HUMAN FACTORS ENGINEERING REVIEW AND EVALUATION

HUMAN FACTORS ENGINEERING
REVIEW AND EVALUATION OF TITAN WEAPON
SYSTEM 107A-2 LAUNCHER, OSTF & TF-1

31 January 1962
Volume II
Chapter 16 - 26

**FIGURE 17-1
HUMAN FACTORS INPUTS
POWER PACK
ROOM**

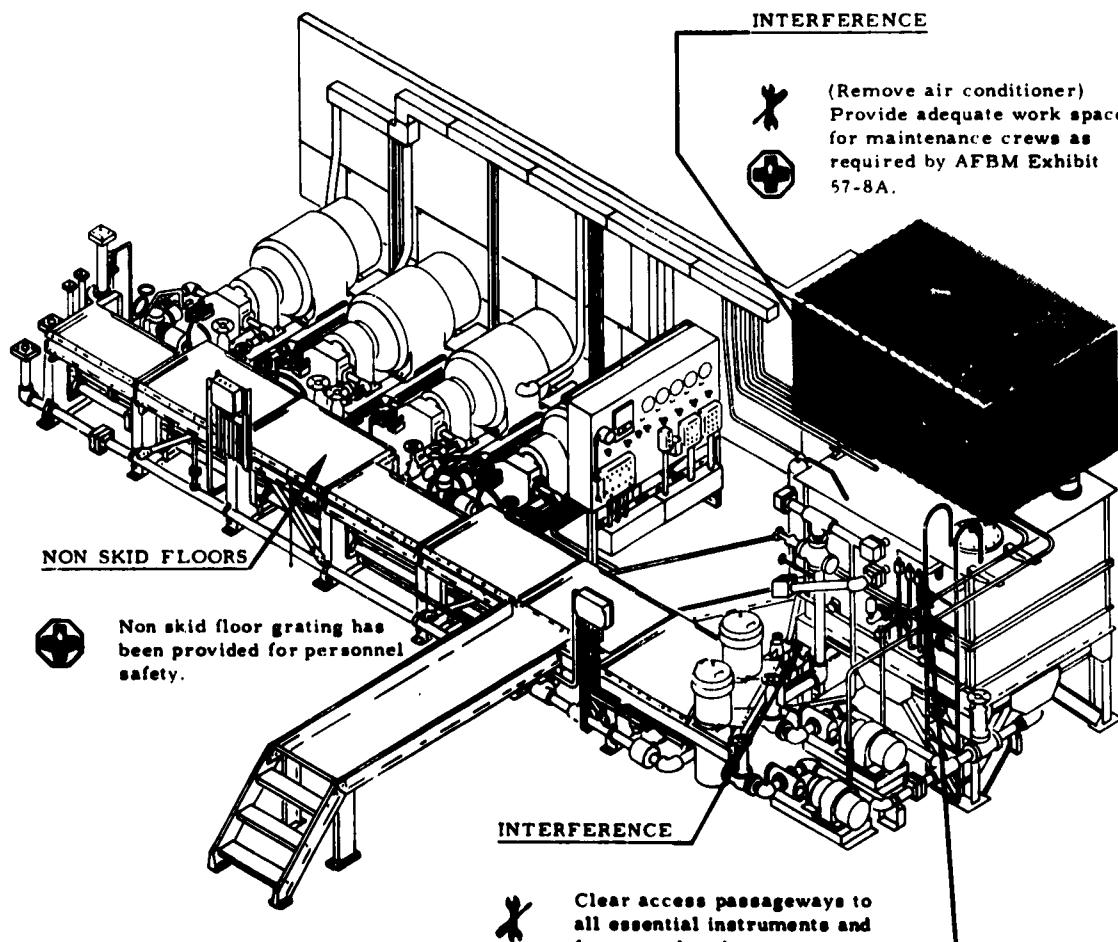
Provide noise protection to reduce human error in telephone conversations, to reduce possibilities of injury to personnel, and to increase efficiency of human performance.

Provide hazard warning signs to comply with A.S.A. Z 35.1 - R 1945.

Provide ladders to comply with A.S.A. A 14.3 - 1956

FIGURE 17-2
HUMAN FACTORS INPUTS
CYCLING CONTROL
STATION

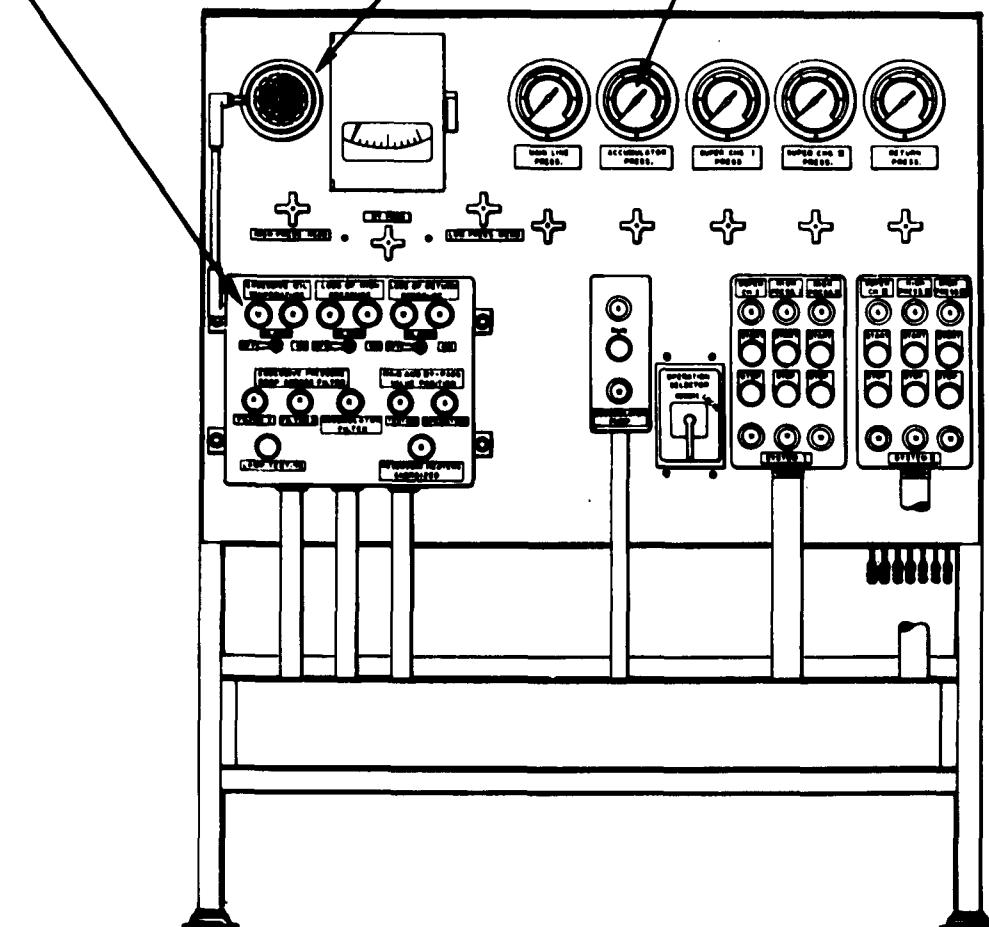
Locate pressure gauges so that normal readings are at 9 o'clock position.

FIGURE 20-1
HUMAN FACTORS INPUTS
GROUND LEVEL PORTABLE CONTROL STATION

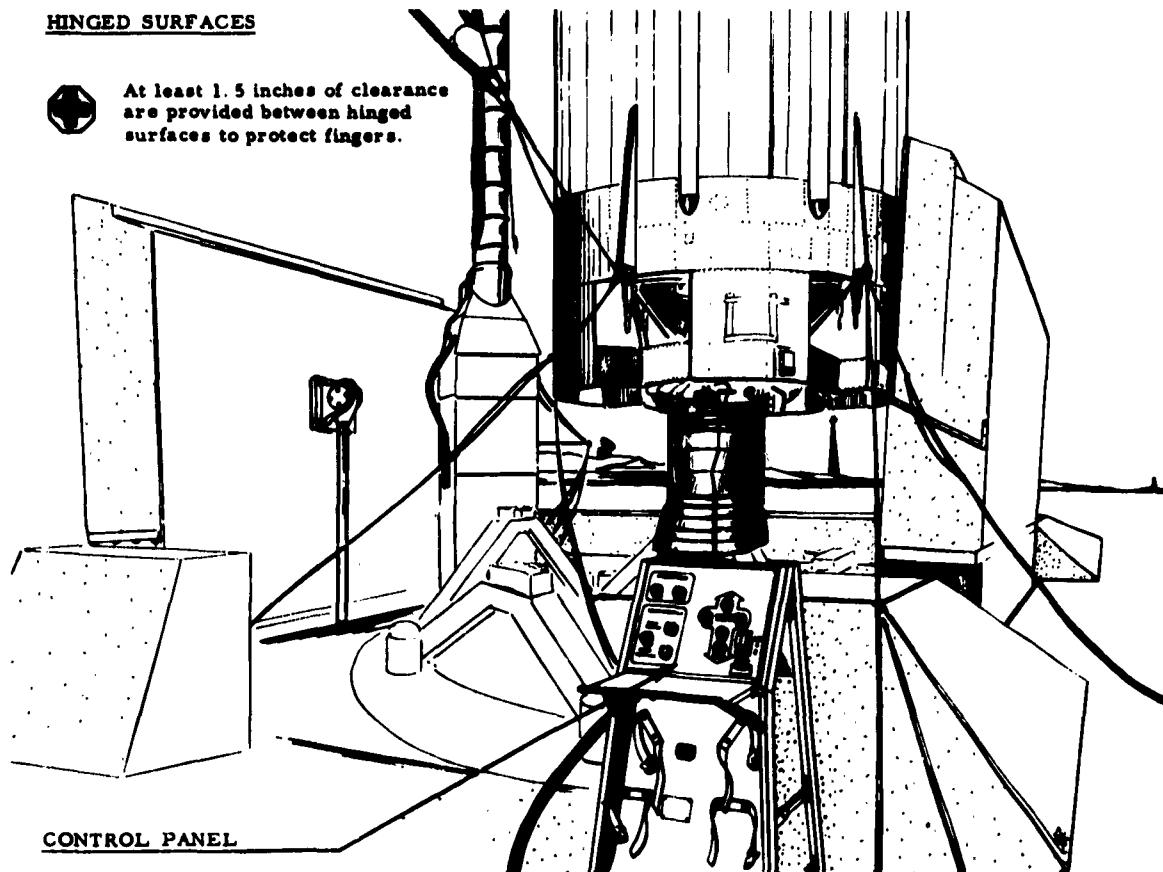
A weather cover is recommended for protection against the elements.

**FIGURE 20-2
HUMAN FACTOR'S INPUTS
TUNNEL ENTRANCE CONTROL STATION**

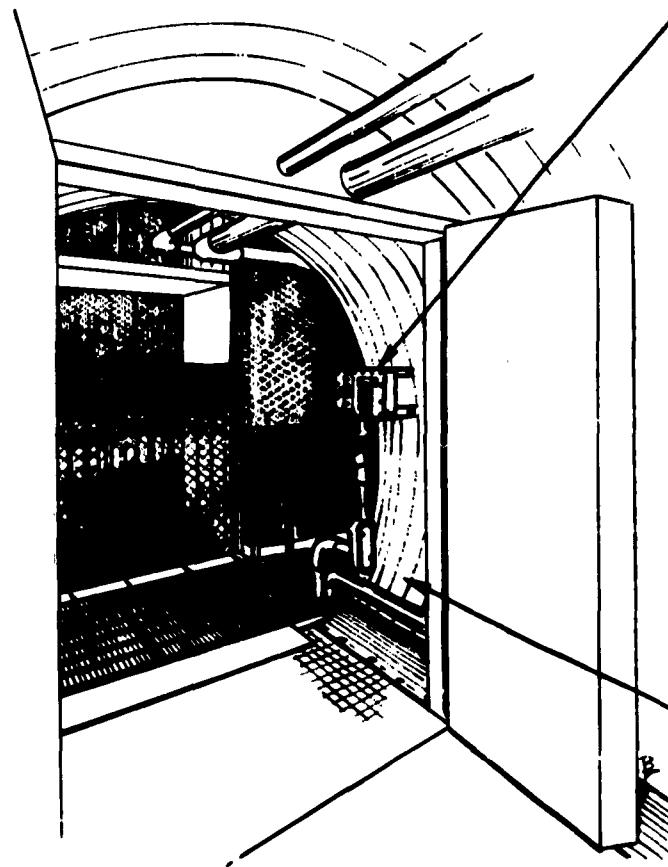
Glare proof lighting is recommended.

FIGURE 21-1
HUMAN FACTORS INPUTS
MAIN DRIVE

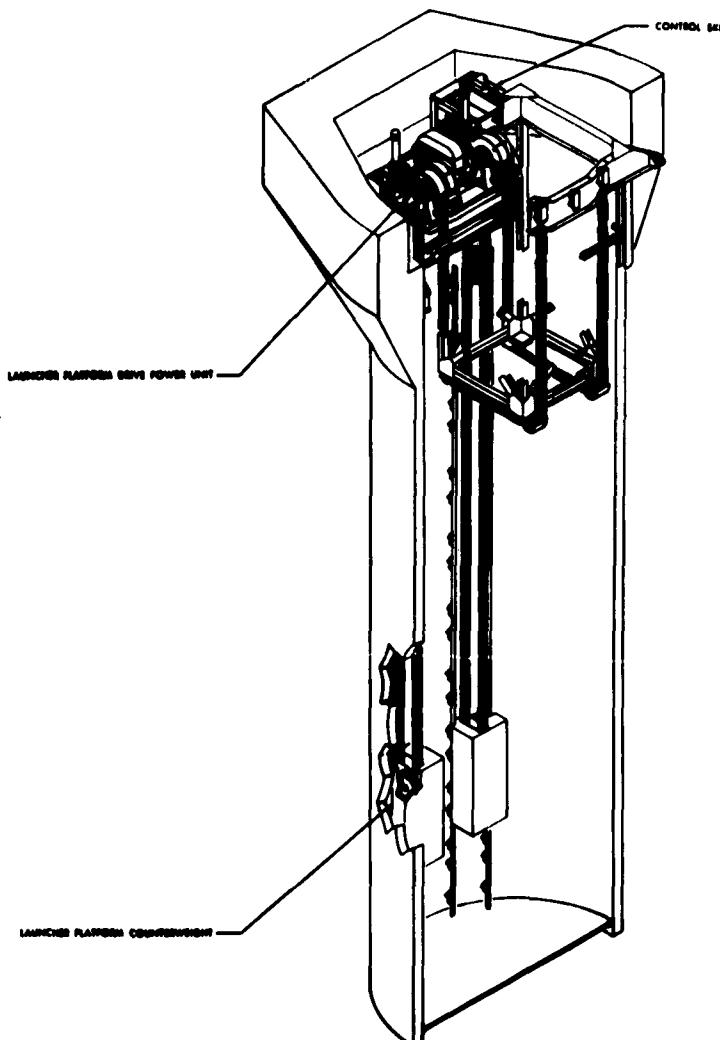
A ladder should be added from
platform 1 to provide access
to the drive base. A ramp
should be provided over the
drive base to the catwalk.

FIGURE 24-2
HUMAN FACTORS INPUTS
EMERGENCY LADDER
SAFETY RAIL & SLEEVE

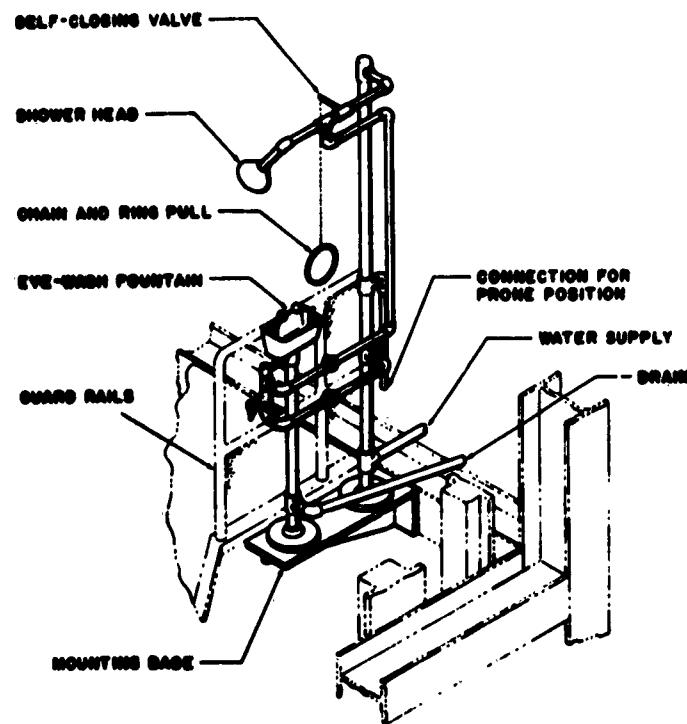
Provision should be made to switch safety sleeves on or off safety rail at any platform level. Safety sleeves and belts should be permanently combined.

FIGURE 26-2
FAIL SAFE WORK PLATFORM
DESIGN

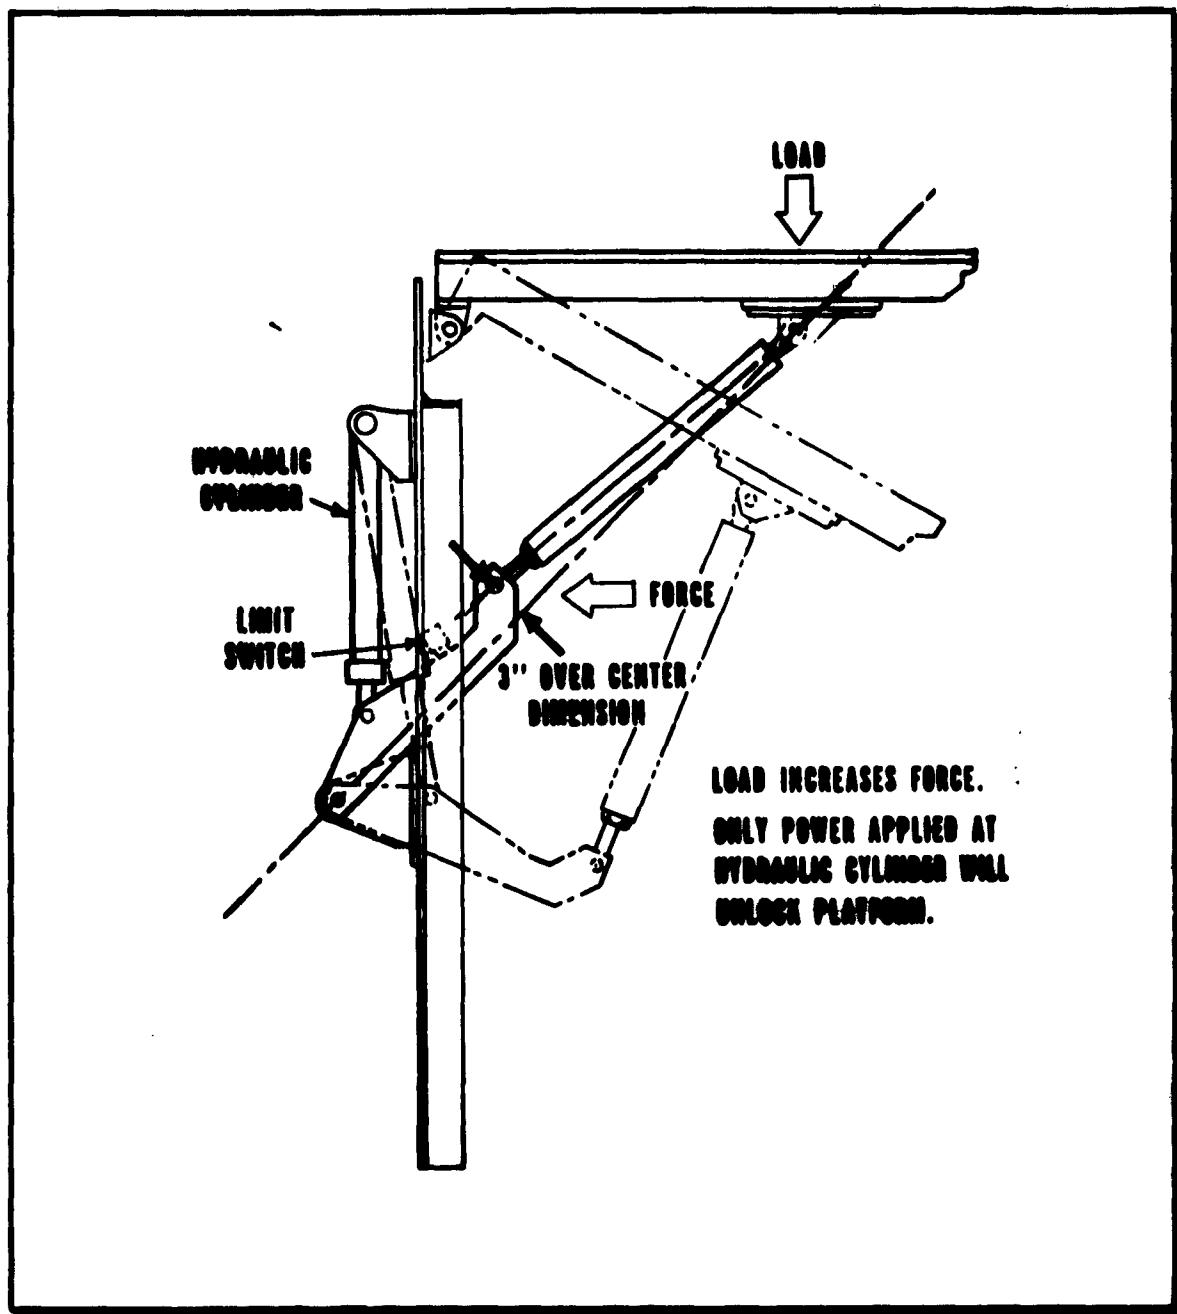
Handrail sections should be simplified for ease of emplacement.
